RACE CODE
METHODOLOGY AND VERIFICATION

Additional Information in Response to Question 1.

CYCLE 1 EPRSTPT - ALGEBRAIC SLIP VS PLANT

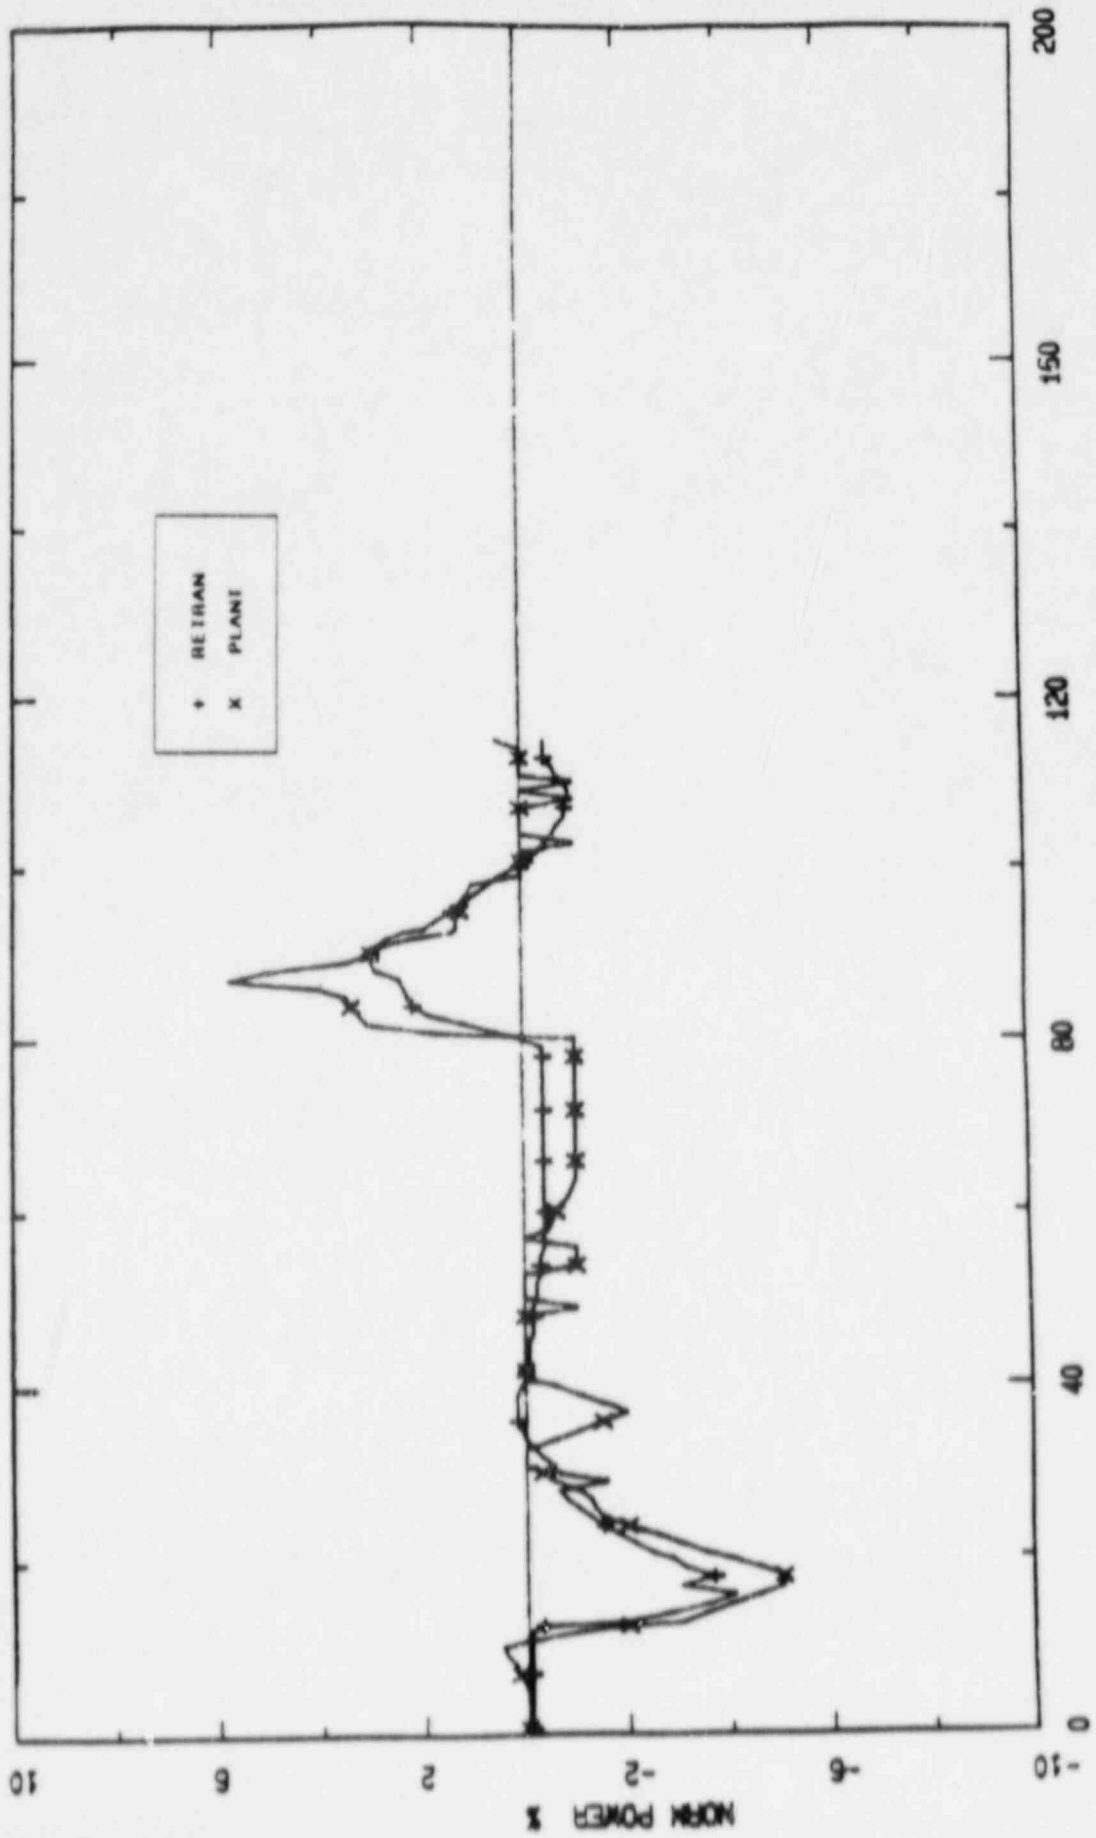
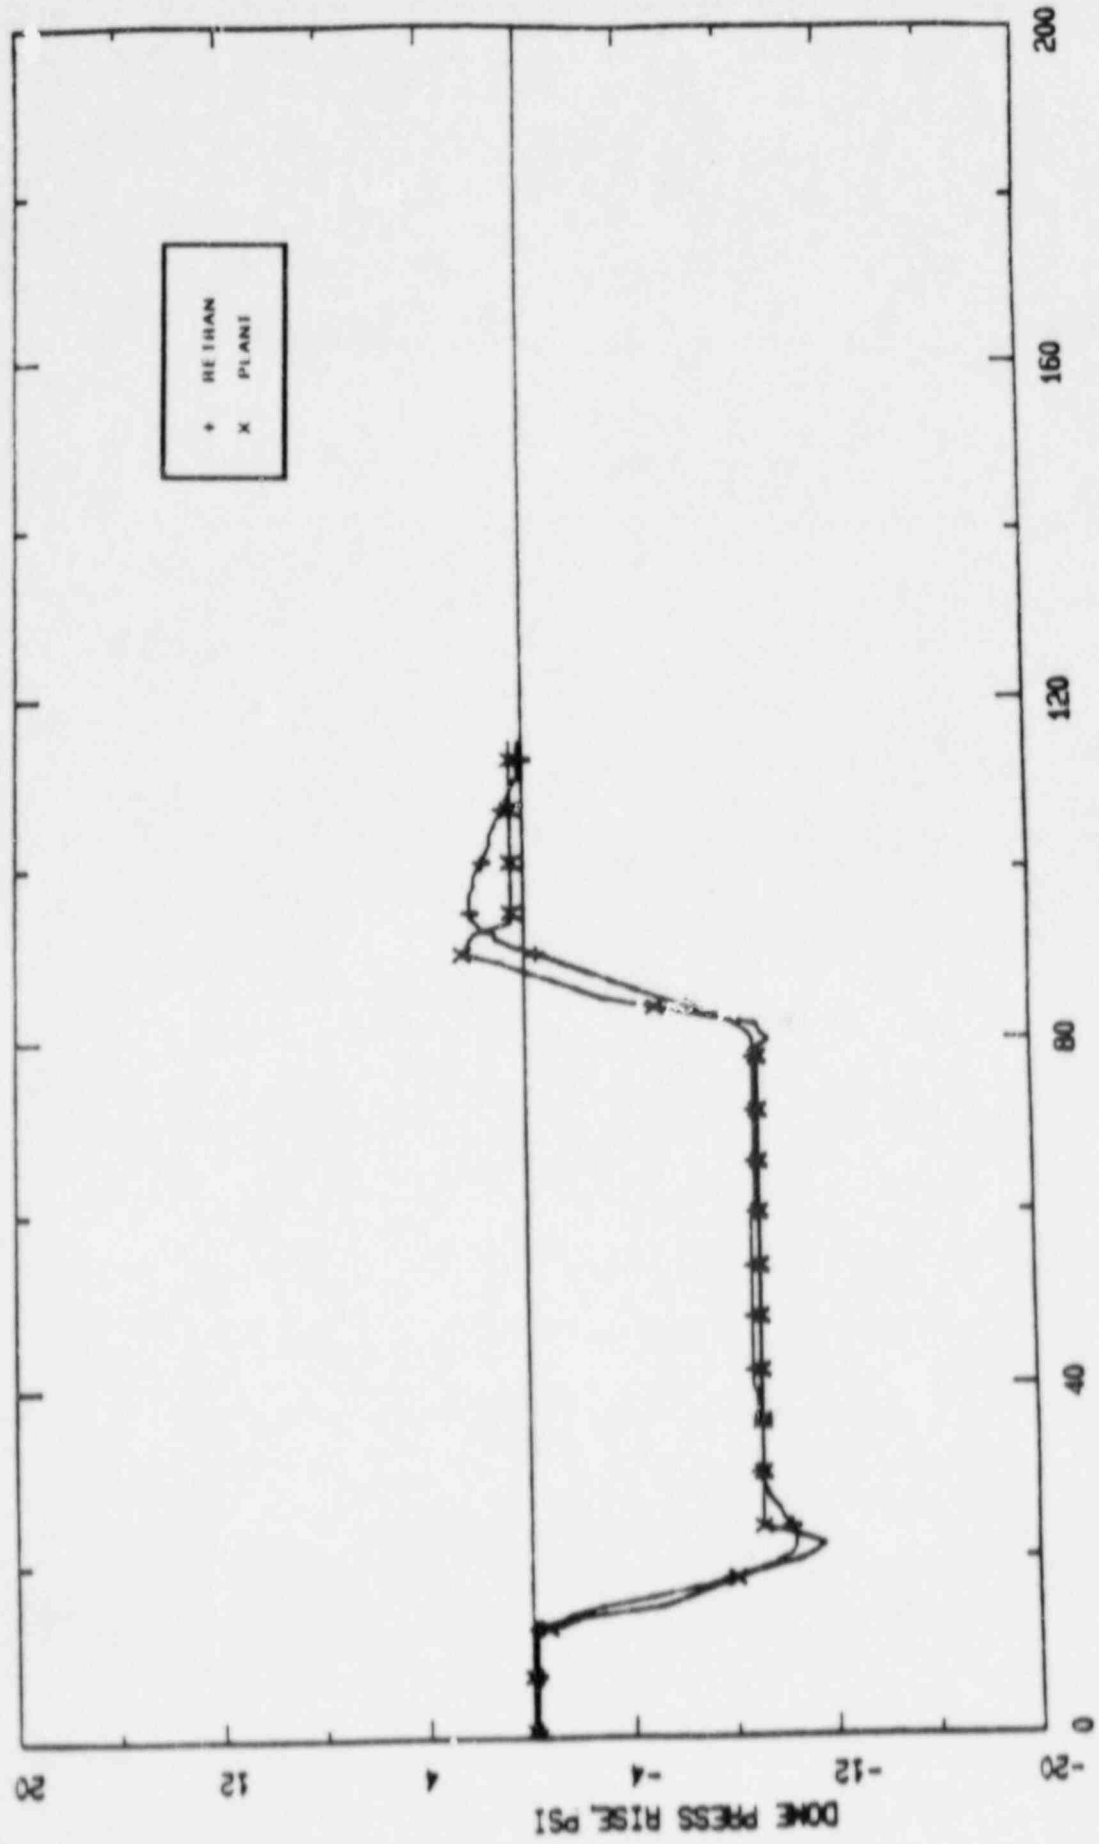
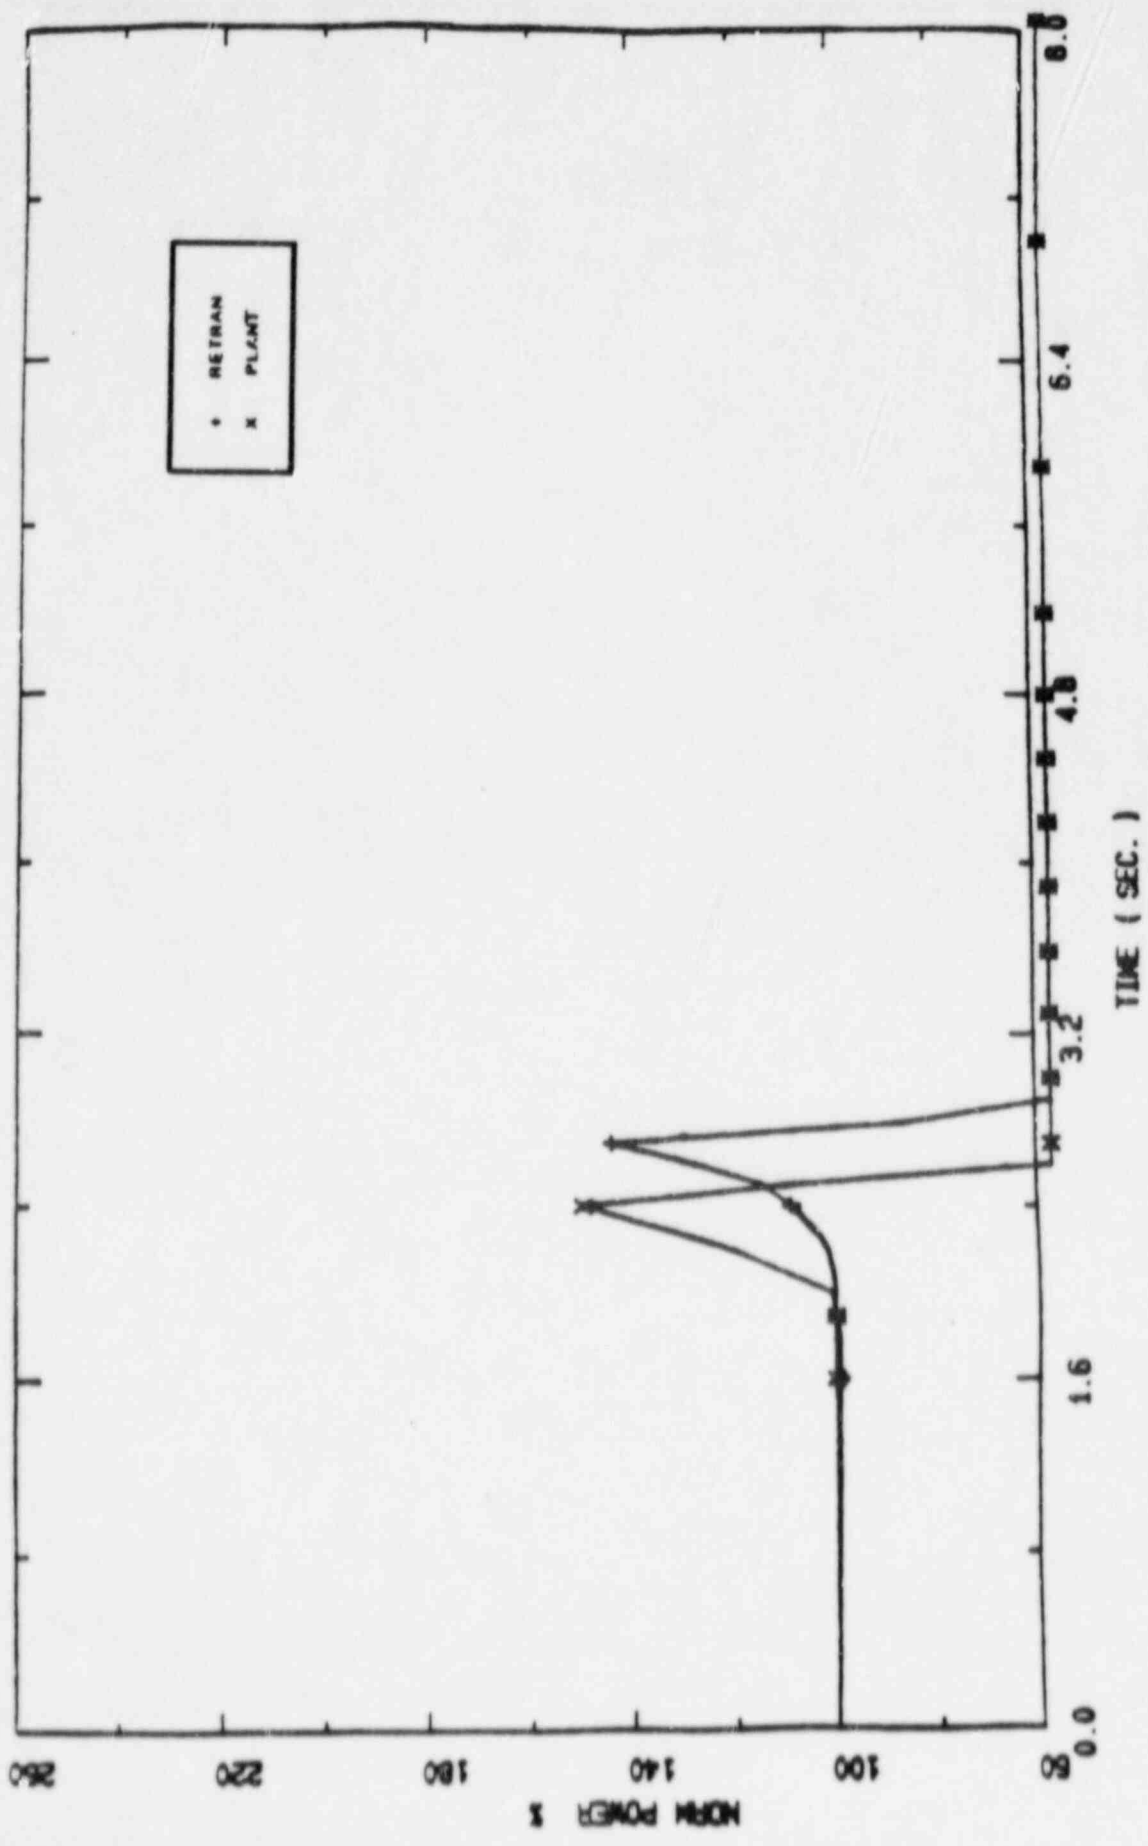
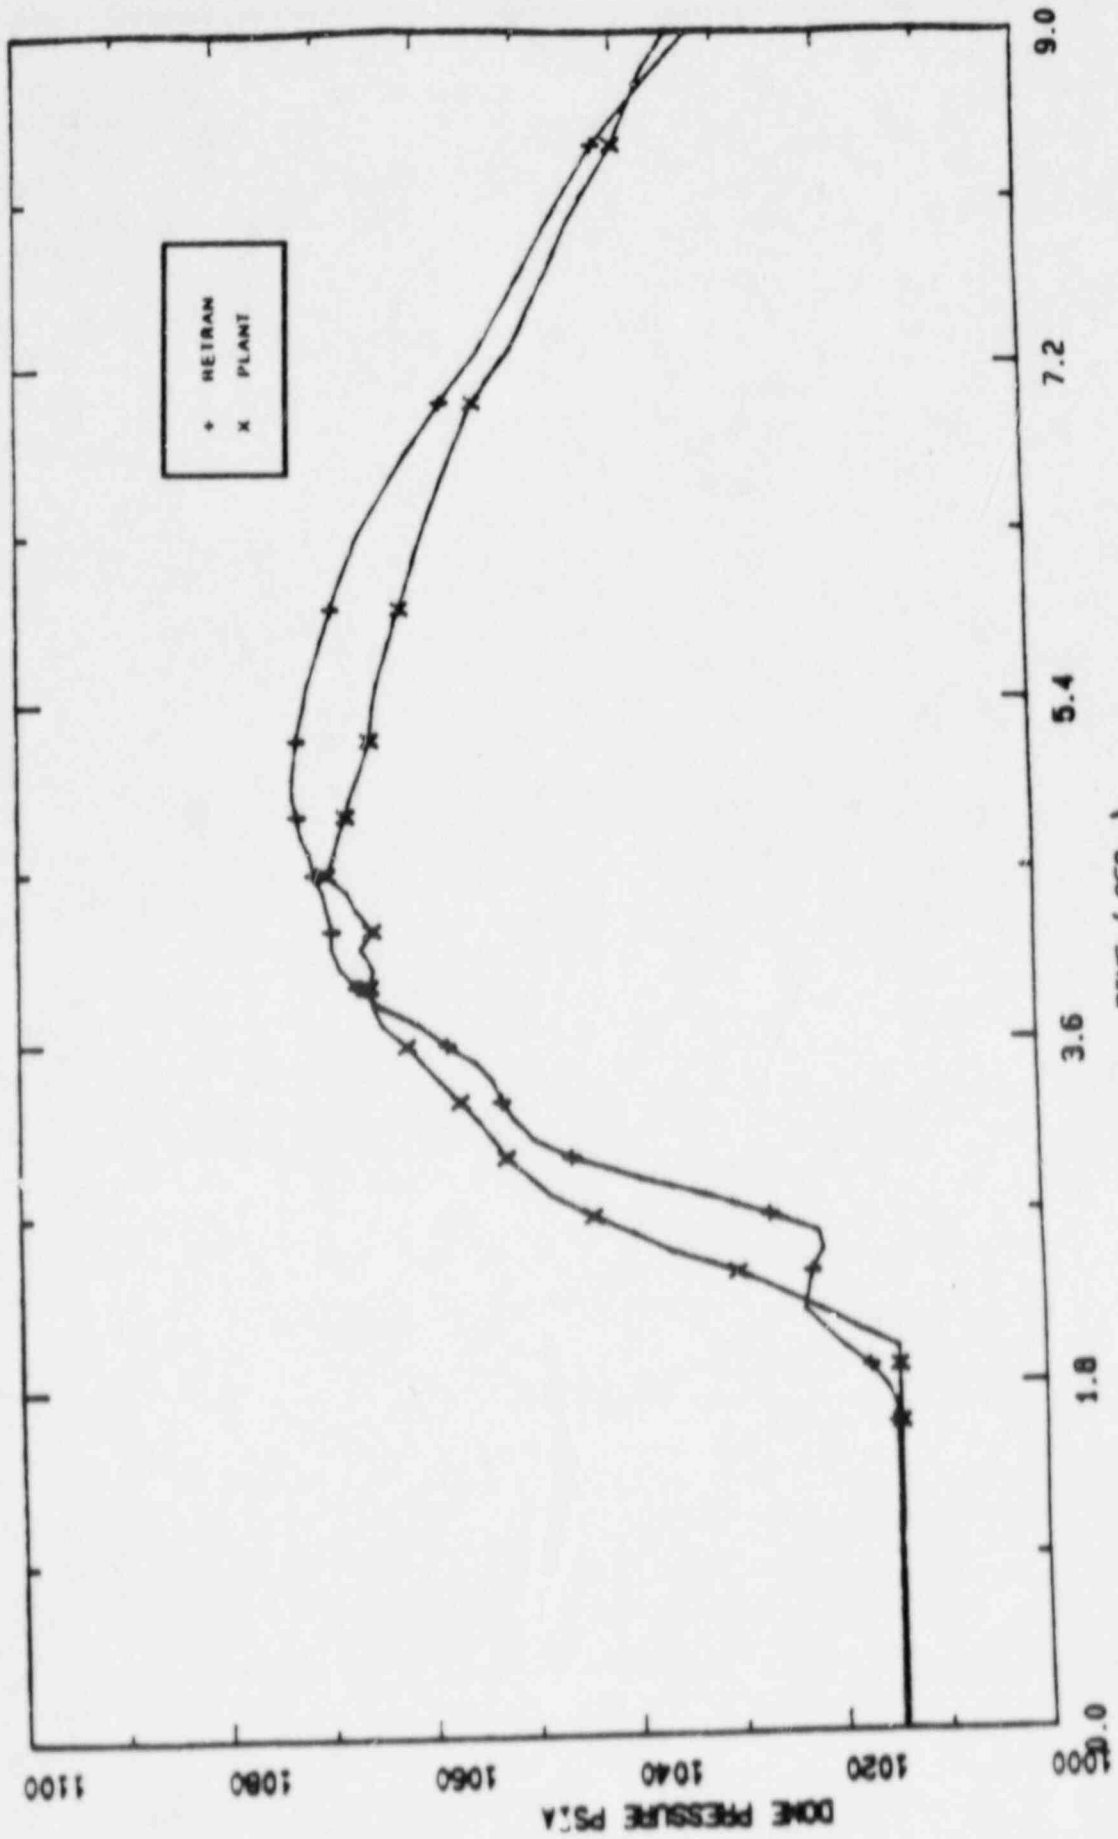
Four startup tests have been reanalyzed using the algebraic slip option (as opposed to the dynamic slip originally used). Those tests were the level setpoint change, the pressure setpoint change, turbine trip and the generator trip. Those tests cover the small perturbations to the severe pressurization conditions. Results presented in figures 1.1 - 1.8 show that the algebraic slip gives results comparable to the dynamic slip in comparison to plant data. Furthermore, use of the algebraic slip model in the context of GPUNs overall RETRAN modeling, provides a more conservative result (in terms of ΔCPR) than the current licensing model (ODYN) for the reload transients analyzed (see Table 1.1). An additional model uncertainty has been included for use of algebraic slip and is discussed with the additional information provided for questions 15 and 21. As such, the use of the algebraic slip model is acceptable for its intended application.

FIGURE 1.9
RETRAN/RACE CPR CALCULATION

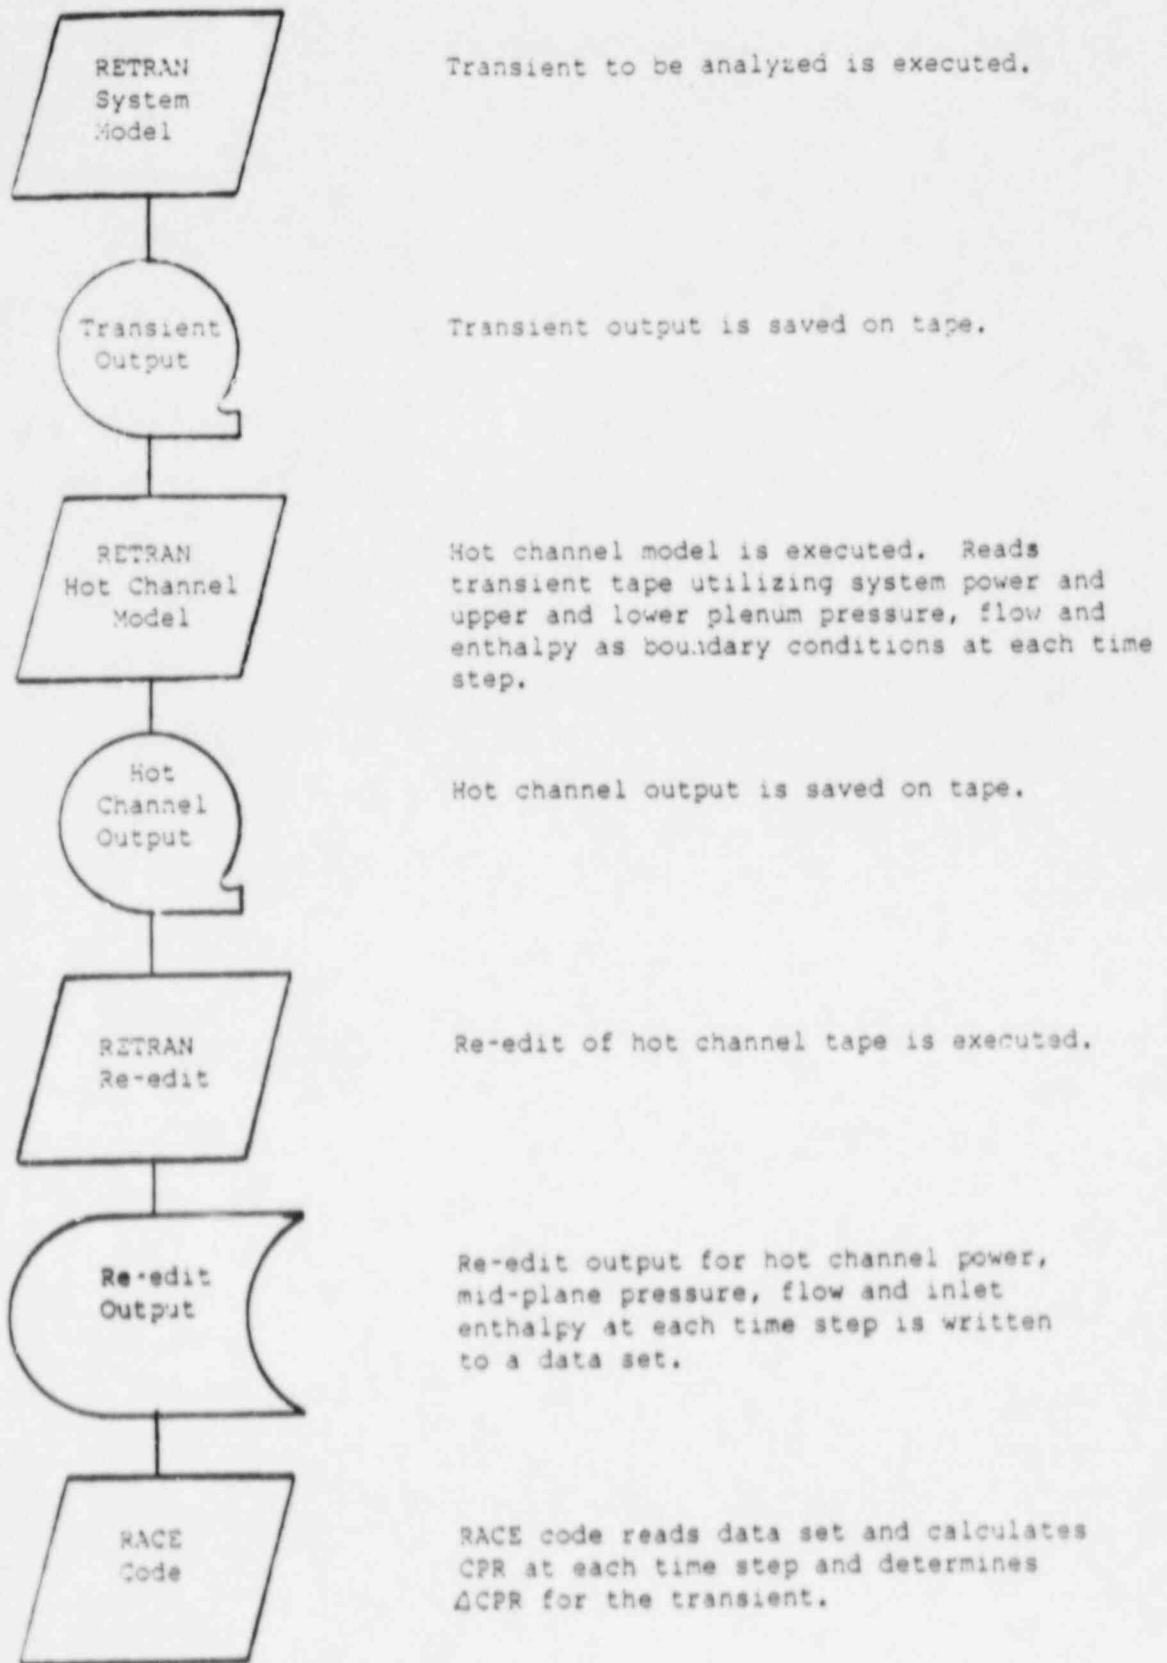
Figure 1.9 shows a schematic of the data flow for a transient critical power ratio calculation using GPUN methods. The RETRAN system model calculation is performed for a given event and the output is stored on a data tape. This tape contains all the thermal hydraulic (T/H) and neutronic results which provide time-dependent boundary conditions to a RETRAN hot channel analysis. The hot channel model uses system power and upper and lower plenum pressure, flow and enthalpy as boundary conditions at each time step. For licensing calculations, a generic design axial power distribution is used in the hot channel calculation. GPUN uses this axial power shape since it is an approved power shape for use in the General Electric Thermal Analysis Basis (GETAB) which GPUN utilizes for its MCPR safety limit. The hot channel power is set such that the initial steady-state CPR is at or greater than the established MCPR operating limit since ΔCPR increases with increasing initial CPR.
